I, SCOTT J. STEFFEN, NMPE 14664, OF THE FIRM BOHANNAN HUSTON, HEREBY CERTIFY THAT THIS PROJECT IS IN SUBSTANTIAL COMPLIANCE WITH AND IN ACCORDANCE WITH THE DESIGN INTENT OF THE EPC APPROVED PLAN DATED 2/22/12. THE RECORD INFORMATION EDITED ONTO THE ORIGINAL DESIGN DOCUMENT HAS BEEN OBTAINED BY SURVTEK. I FURTHER CERTIFY THAT I HAVE PERSONALLY VISITED THE PROJECT SITE ON 1/31/13, 2/13/13, 4/18/13, 5/23/13, 6/17/13, 6/27/13, 8/1/13, 8/28/13, 11/5/13, 11/14/13, 12/23/13 AND 1/30/14 AND HAVE DETERMINED BY VISUAL INSPECTION THAT THE SURVEY DATA PROVIDED IS REPRESENTATIVE OF ACUTAL SITE CONDITIONS AND IS TRUE AND CORRECT TO THE BEST OF MY KNOWLEDGE AND BELIEF. THIS CERTIFICATION IS SUBMITTED IN SUPPORT OF A REQUEST FOR PERMANENT CERTIFICATE OF OCCUPANCY.

SITE DEVELOPMENT PLAN
FOR BUILDING PERMIT
DIAMOND MESA

ADMINISTRATIVE AMENDMENT
FILE # 13-10302 **PROJECT #** 1002819
SEE ⚠2
2/13/2014
APPROVED BY **DATE**

⚠2 Revised February, 2014

Sheet 1 of 15

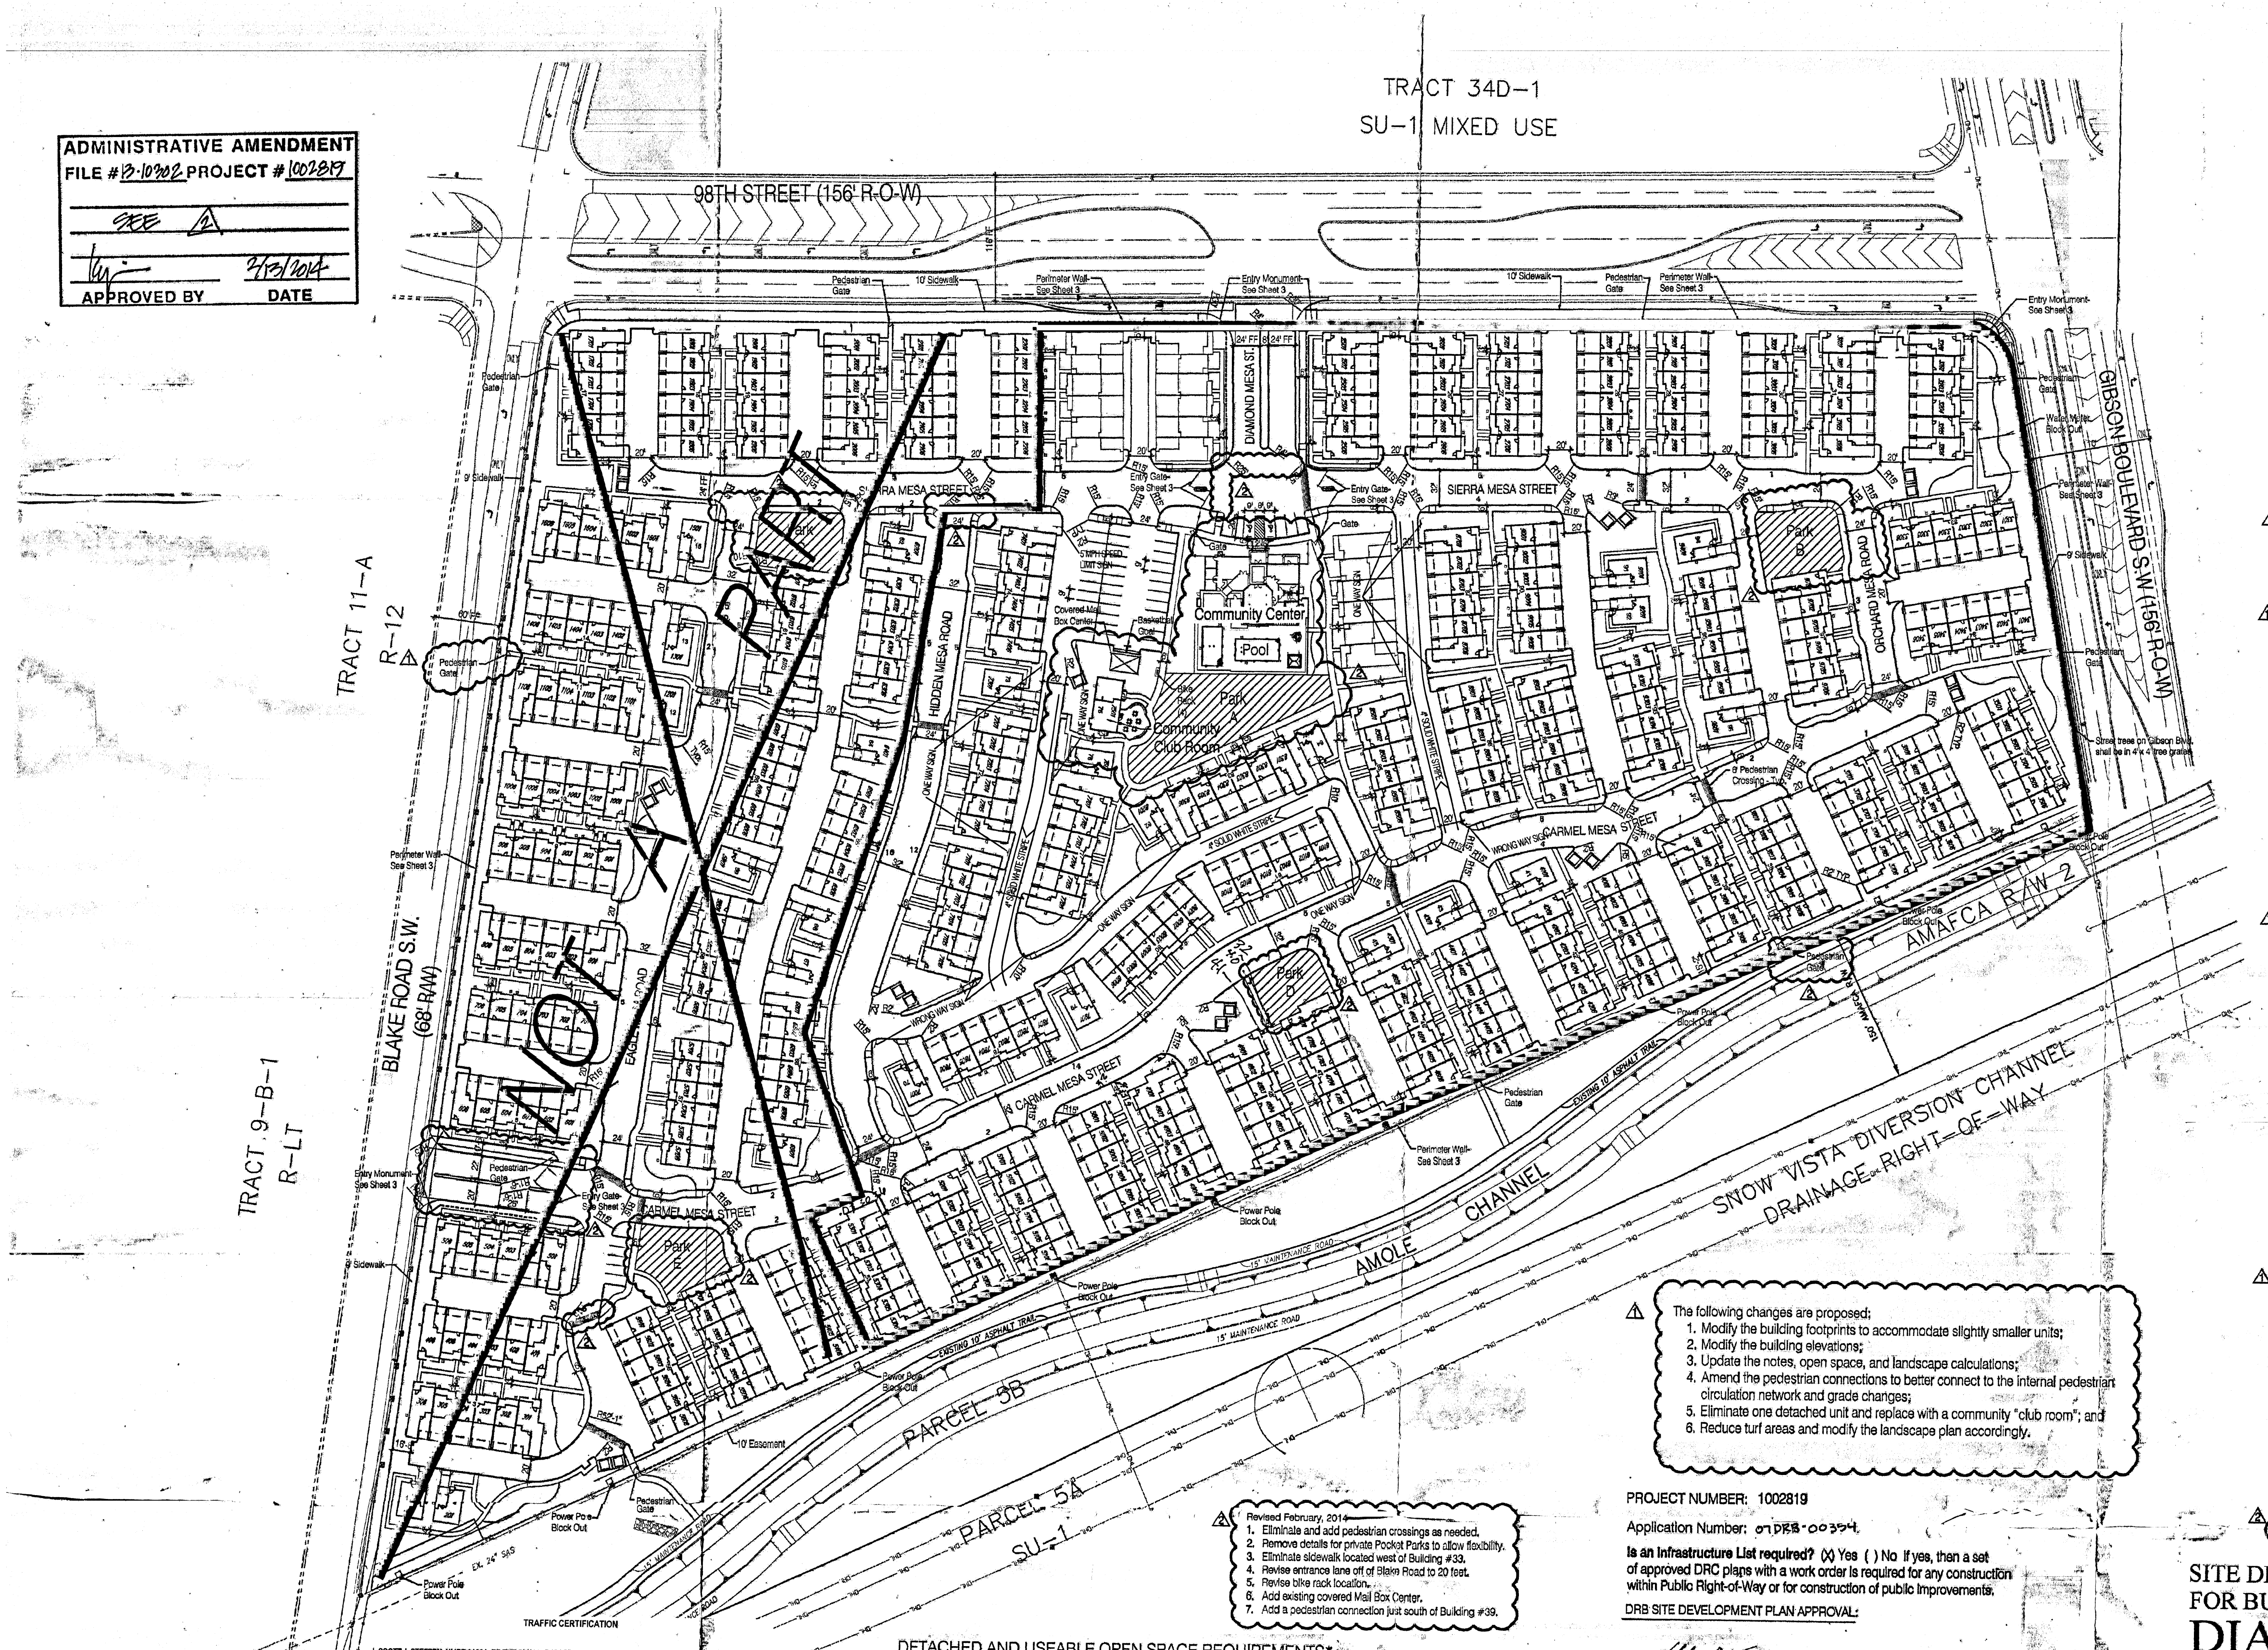
1. Modify the building footprints to accommodate slightly smaller units;
2. Modify the building elevations;
3. Update the notes, open space, and landscape calculations;
4. Amend the pedestrian connections to better connect to the internal pedestrian circulation network and grade changes;
5. Eliminate one detached unit and replace with a community "club room"; and
6. Reduce turf areas and modify the landscape plan accordingly.

⚠2 Revised February, 2014

1. Eliminate and add pedestrian crossings as needed.
2. Remove details for private Pocket Parks to allow flexibility.
3. Eliminate sidewalk located west of Building #33.
4. Revise entrance lane off of Blake Road to 20 feet.
5. Revise bike rack location.
6. Add existing covered Mail Box Center.
7. Add a pedestrian connection just south of Building #39.

Sheet 1 of 15

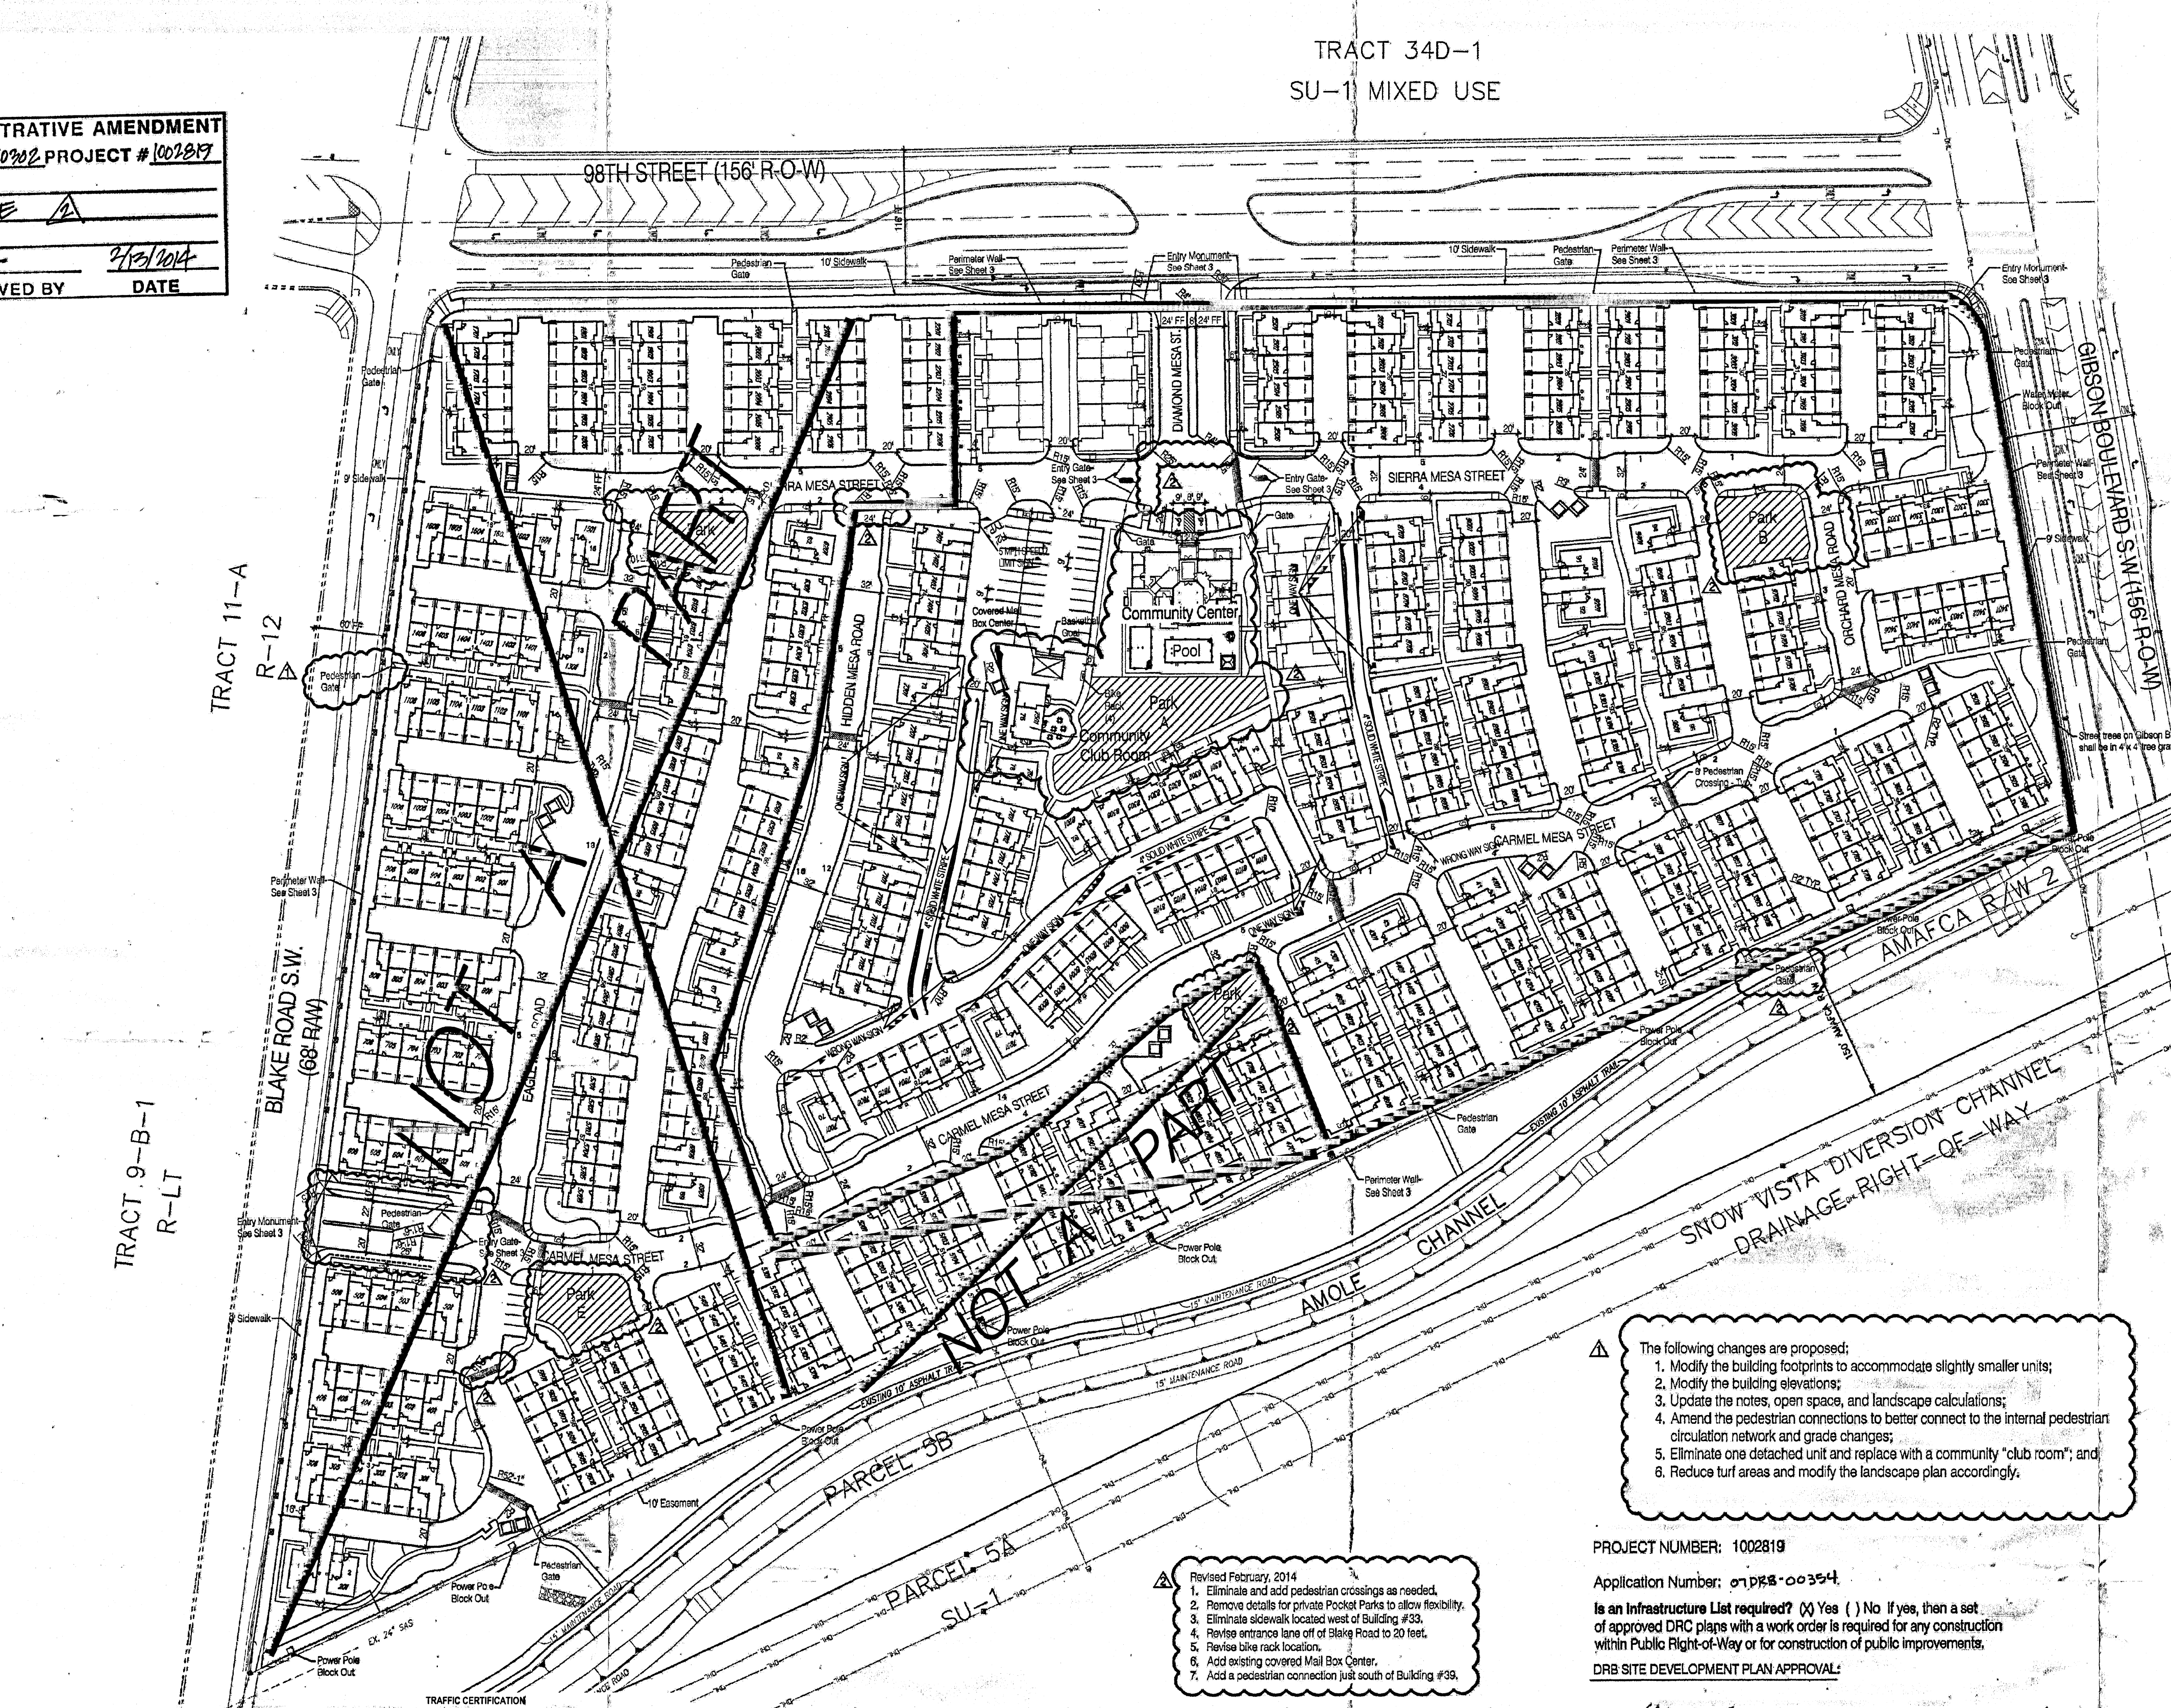
△ The following changes are proposed;

1. Modify the building footprints to accommodate slightly smaller units;
2. Modify the building elevations;
3. Update the notes, open space, and landscape calculations;
4. Amend the pedestrian connections to better connect to the internal pedestrian circulation network and grade changes;
5. Eliminate one detached unit and replace with a community "club room"; and
6. Reduce turf areas and modify the landscape plan accordingly.

△2 Revised February, 2014

1. Eliminate and add pedestrian crossings as needed.
2. Remove details for private Pocket Parks to allow flexibility.
3. Eliminate sidewalk located west of Building #33.
4. Revise entrance lane off of Blake Road to 20 feet.
5. Revise bike rack location.
6. Add existing covered Mail Box Center.
7. Add a pedestrian connection just south of Building #39.
